Staff Report

To: BOZAR
From: Jessie Earley, Town Planner III
Meeting Date: DRC, March 10, 2025
RE: 422 and 422 ½ Sopris Avenue, Secondary Review

PROJECT TITLE: Breuer Residence (422 Sopris Avenue)

SUMMARY: Consideration of the application of **John Andrew Breuer and Amy Padgett Breuer** to site a new single-family residence and accessory dwelling to be located at 422 and 422 ½ Sopris Avenue, Block 35, Lots 5-6 in the R1C zone. *Continued from the January 28, 2025 BOZAR meeting.*
(Ryan/Hadley)

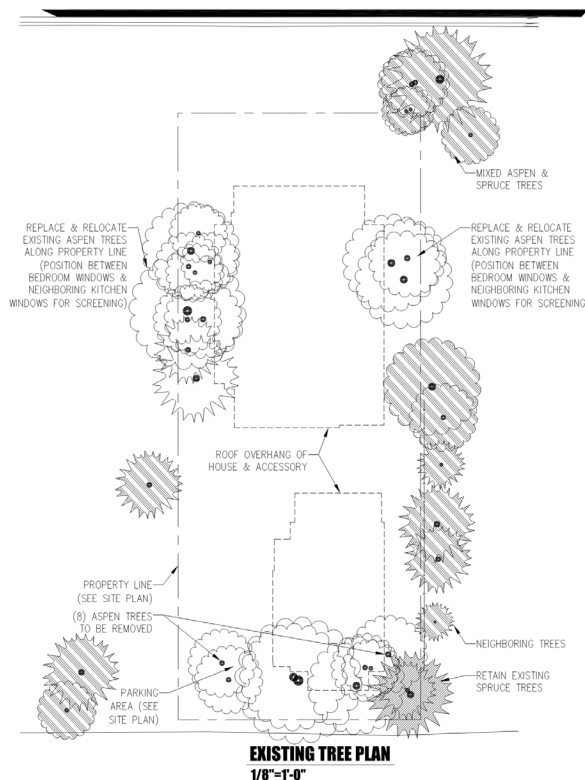
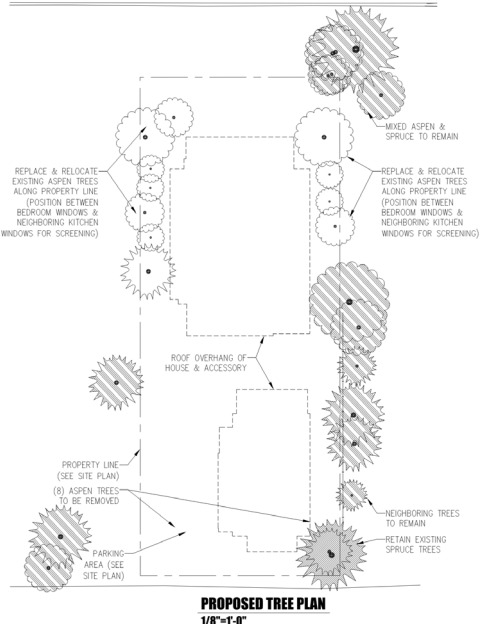
Also, there are trees along the edges of the lot to the west (10) and east (3) and that are noted to be removed and replaced.

There are seven trees on the south that are proposed to be removed to ensure access to the new accessory dwelling.

It appears that all trees that exist on the lot with the exception of the one spruce tree on the southeast corner will be removed. This is excessive and counter to other proposals the Board has reviewed and GL 2.18 a which speaks to trees within side setbacks. There have been other instances where soil nails were used to retain trees. Staff encourages potential retention of large trees on the east and west, thinning out smaller trees and as many trees to remain as possible. There is a suggested provision in the finding about the applicant hiring an arborist to help evaluate this.

The trees on the east and west would be a topic of conversation for the full Board.

1/28 BOZAR: Members had concerns regarding the trees.

The trees on the south were supported for removal due to access for the proposed ADU.

Proposed Site Plan (3/10/2025 BOZAR)

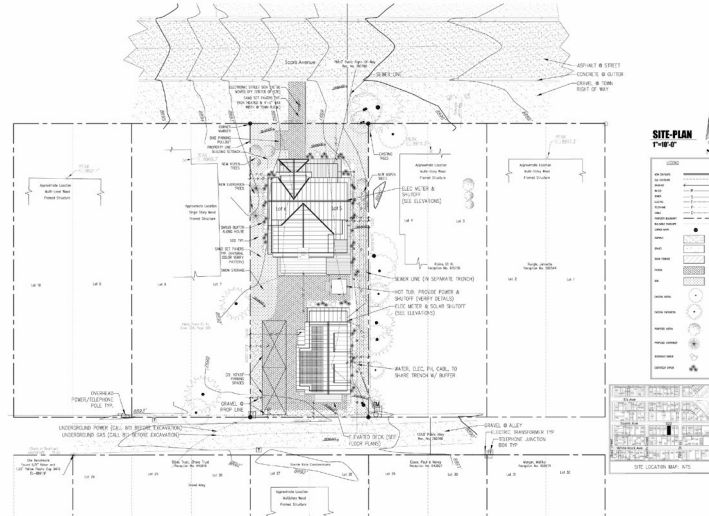
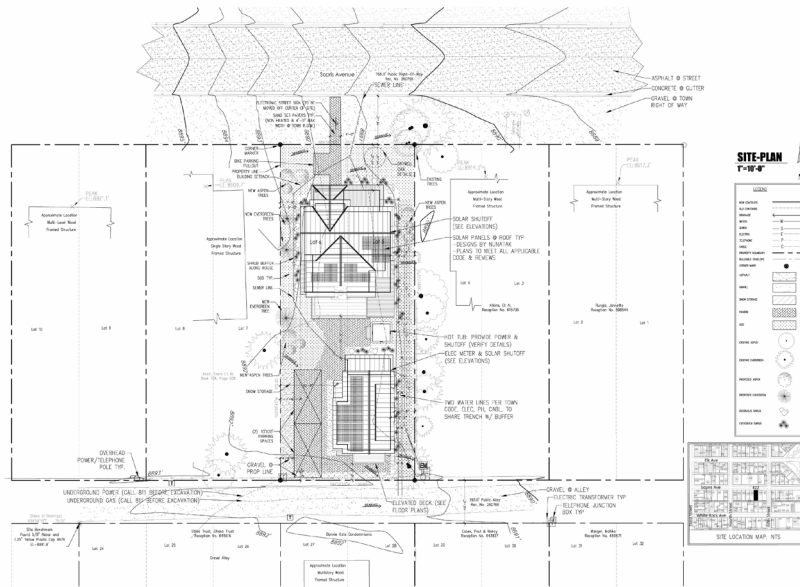
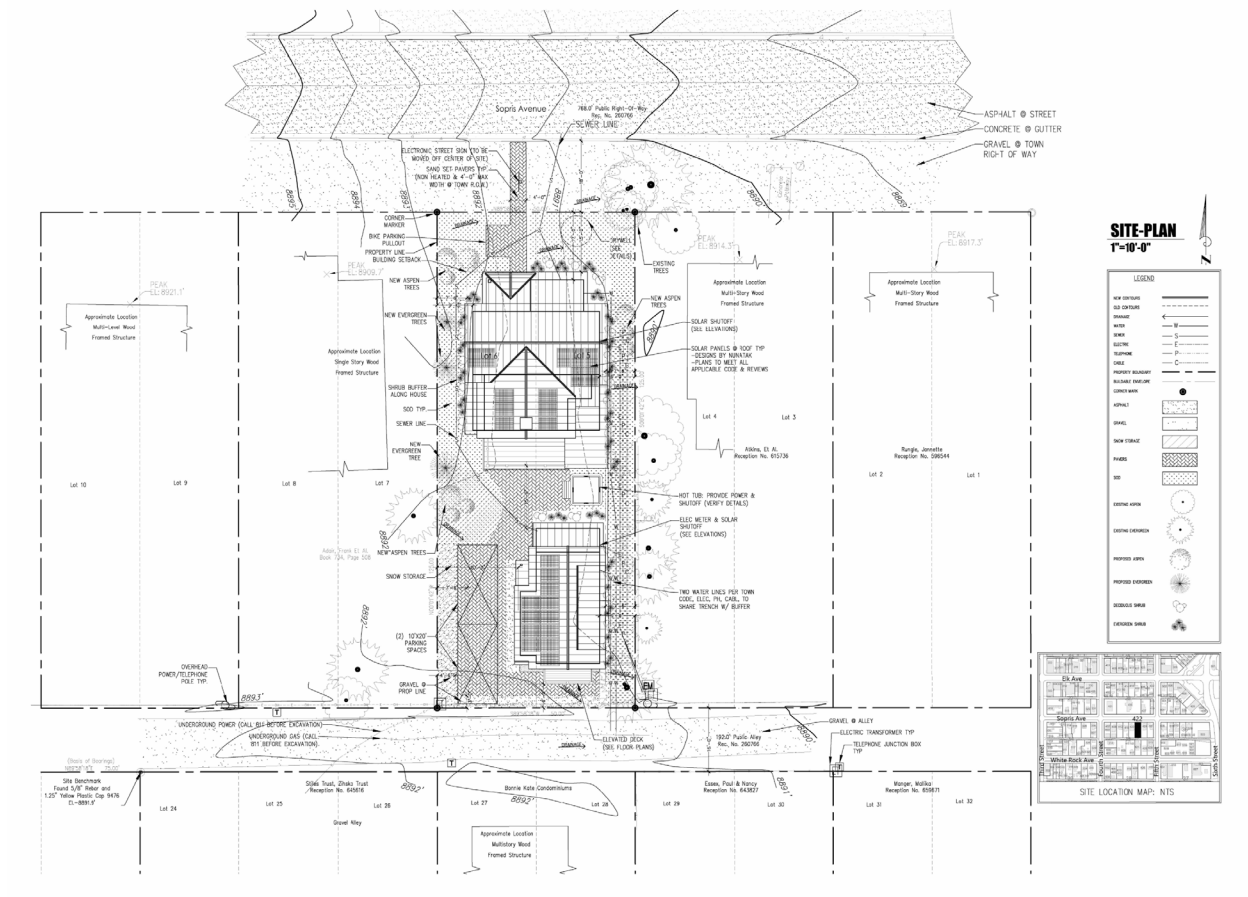
2.8 Drainage	Drainage swales are shown for the primary and accessory building to the east. However, drainage will need to be revised to encourage drainage to the alley or the street not the adjacent lot. A dry well is now shown on the north side of the lot. This will need to meet the specifications required by the Public Works Department.	12/9 DRC: Drainage cannot be to the neighboring property. Revisions needed 1/13 DRC: Drainage cannot be to the neighboring property. Revisions needed
Easements	NA	NA

- Site Plan:
 - Pavers further reduced by:
 - Adding gravel at the garage dripline.
 - Reducing the South West patio & adding grass.
 - Removing the pavers under the Hot Tub & surrounding its concrete pad with grass.

- Limited the entire length of the North walkway to 4'-0" wide.
 - Additional Evergreen & Aspen trees have been added to the South West yard, formerly the patio.

- Drywell Added.
 - Sewer & Water Lines Separated.
 - Two water lines shown by code.
 - Right Of Way dimensions and additional Building Departments notes added, see Astrid's initial review response.

- Site plan:
 - Largely unchanged
 - Open to wildflower & native grasses in the north yard
 - Developing a “Tree Survey and Replanting Plan” which will document and catalog every tree above 3” caliper.
- Primary building:
 - Simplification of the north elevation by removing the gable bump out.
 - Revised windows on the north elevation, second floor.
- ADU:
 - Revised the large shed dormer to be two shed dormers

Revised 3D – 3/10 DRC

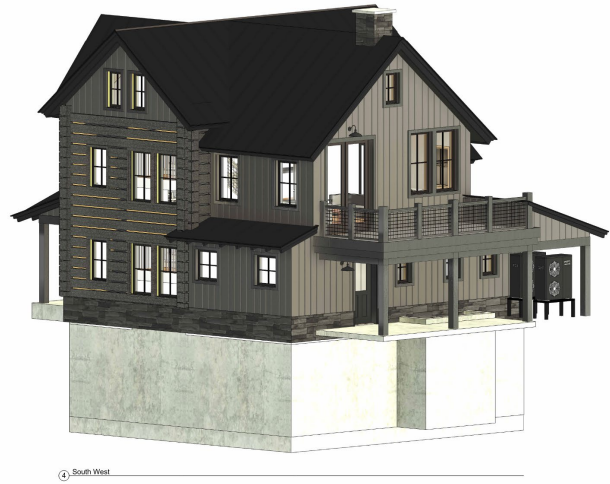
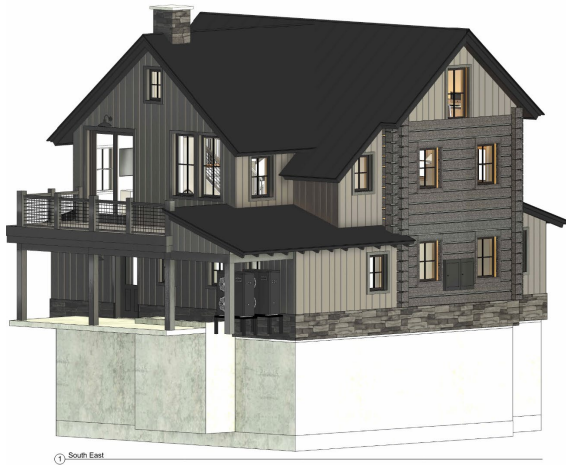
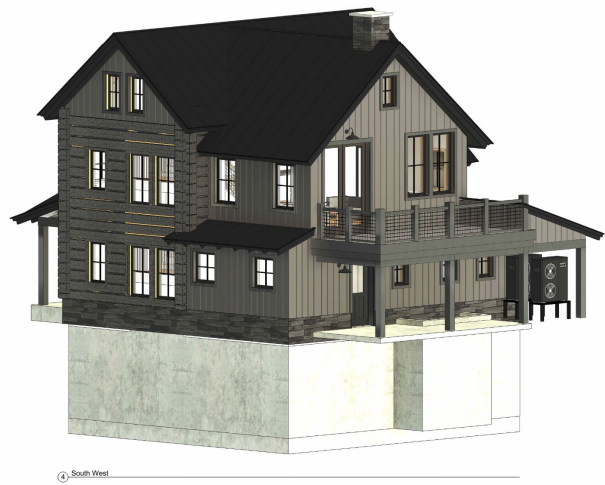
GL	Staff Analysis	DRC Recommendation
4.32-4.33	Consideration of whether the forms better achieve relationships with historic buildings are in GL 4.32-4.34. The 3D drawings are helpful in the review. The removal of the gable module perpendicular to the street and modification of the fenestration has helped to simplify this elevation.	12/9 DRC: Members requested a streetscape to better evaluate mass/scale and form as it relates to the context of the neighborhood. 1/13 DRC: Members had concerns regarding mass/scale/form as seen from the street per GL 4.32 a. One member

<p>GL 4.32 conveys that new infill construction should relate with the predominate scale of historic neighborhoods. An updated streetscape must be provided to assess this. 3D massing for streetscapes have been provided for other projects, which may be necessary. This building is at the height maximum of 28' and below the width maximum of 32' per zoning requirements. The design goals of this zone district encourage infill to help preserve the character of the existing buildings. Once the streetscape is received, discussion is encouraged to determine if revisions are required.</p> <p>Per GL 4.33, a diversity of forms is encouraged. Many of the homes on this south side of the block have a gable facing the street. The gable running parallel to the street varies this appearance.</p>	<p>felt that they could support, as drawn, but gave a suggestion to revise materials to help make the building less complicated. Siding materials have been revised in color.</p> <p>1/28 BOZAR: Members were concerned regarding the forms of the building per GL, as seen from the north/street side due to the contemporary nature.</p>

Revised Front Porch – (3/10/2025 DRC)

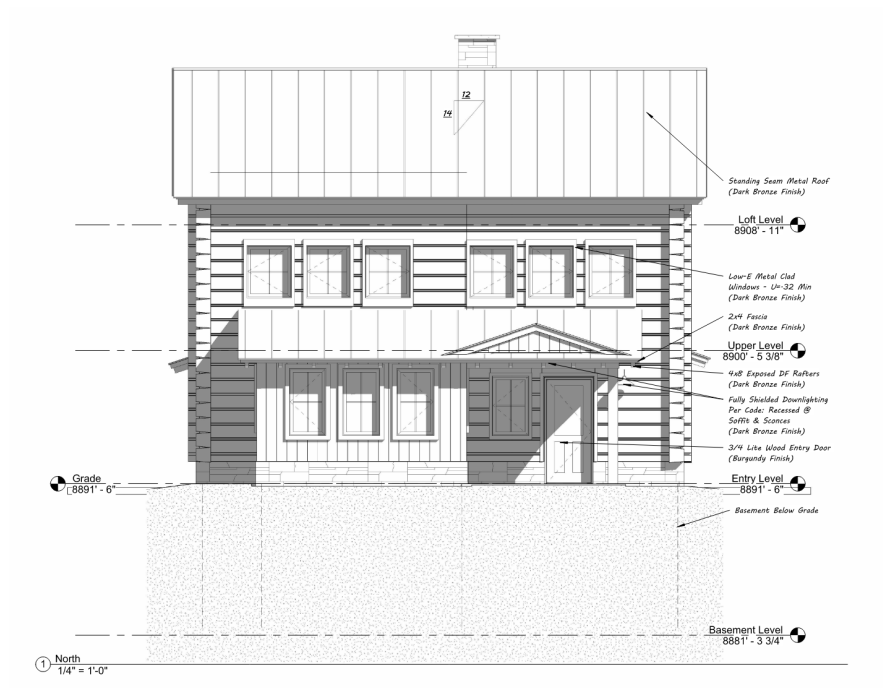
GL	Staff Analysis	DRC Recommendation
4.49/5.118 Primary entrance porch	These GL encourage clearly defining the entry, which is done in many cases with a porch as seen on many historic buildings and also on this building. General support.	Support
4.50 Mix of porch sizes	The front porch is 8'x10'6", which meets the intents of this GL.	Support
4.51 Rear entry porch	The porch on the rear is simpler with the shed than the front porch, as asked for in GL 4.51.	Support

Revised Elevations -3/10/2025 DRC

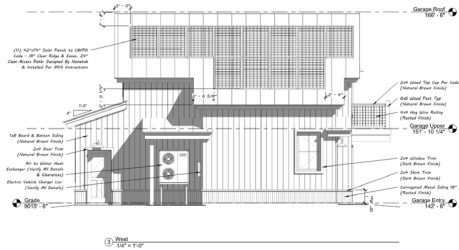
GL	Staff Analysis	DRC Recommendation
4.46 Dormers in new construction	There are two shed roof elements	1/13 DRC: Members expressed that this

proposed for the east elevation, as was proposed in the original design. Discussion is needed to determine if the Board considers this a dormer. If so, it is a shed dormer, which is supported by this GL.	is a dormer. 1/28 BOZAR: Members expressed that the large element was a dormer and needed to meet the GL.

4.47 Dormers	The two shed dormers steps down 1'10" from the ridge of the garage module and achieves subordination. a. As proposed the two occupy 29.7% of the roof. b. The dormers are lower than the ridge. There is not a section of roof beneath either, as required in core zones. c. As proposed the two occupy 29.7% of the roof. d. The proposed shed dormers extend past the middle third on both the south and north sides. e. Met.	1/13 DRC: Members expressed that this was a dormer due to the language in 4.47 b. requiring it in core zones. With that in mind, it doesn't comply with GL noted. 1/28 BOZAR: Members expressed that the large element was a dormer and needed to meet the GL.

4.87 Dormers on ADU	4.87 b. See above. c. Both break the eave line and aren't less than 3' than 24'. d. NA	1/28 BOZAR: Members expressed that the large element was a dormer and needed to meet the GL.
